Accessibility Review – DRAFT 8th March 2022

PUBLIC REALM IMPROVEMENT PROPOSALS

TEMPLE BAR SQUARE AREA

for Dublin City Council Road Design & Construction Division

Figure 4 Layout as Approved 2017

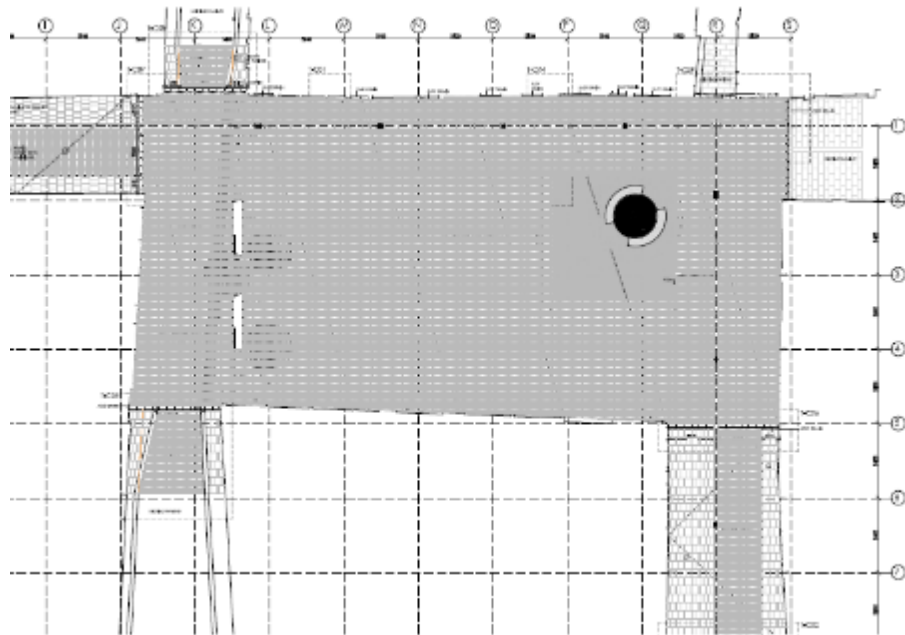
- 3.1.9 The original scheme had eliminated kerbs along Temple Bar and Crown Alley and had proposed a kerb free shared surface with pedestrian areas on both sides defined by a drainage channel and change of paving type and size. The revised scheme has retained the vertical kerbs along both Temple Bar and Crown Alley and has ramped up to the kerb-free area across the Square at the intersection of each street with the Square. A pedestrian crossing has been introduced at each intersection

- 3.1.10 Surface finishes on the vehicular routes along Fownes Street and Temple Bar were originally proposed as re-laid Dublin setts (cobblestones). Surface finishes on the Square and along the centre section of Crown Alley were proposed as re-laid Dublin setts but with the tops “sawn” to provide a smooth surface finish. New Leinster granite was proposed along the kerb-free pedestrian routes on Crown Alley and Temple Bar. The revised proposal has limited the re-laid Dublin setts to the carriageways in Crown Alley and Temple Bar and proposed Leinster granite along all segregated footpaths and accessible routes with new “Azul Platino” Spanish granite in different formats within the Square, similar to the material palette used in the Grafton Street Quarter.

Figure 4 Seating as used in Grafton Street Quarter with solid base

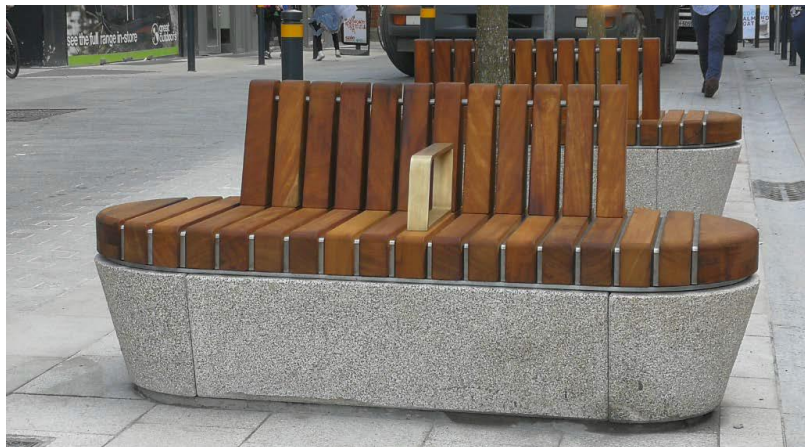
- 5.5.2 The seating around the square is proposed to be selected from OSMOS GSQ range, as used in the Grafton Street Quarter. NCBI has expressed a preference that the stone base should be continuous so as to be detectable by a white cane user. Ideally the stone base should visually contrast with the paving so as to be more readily detectable.
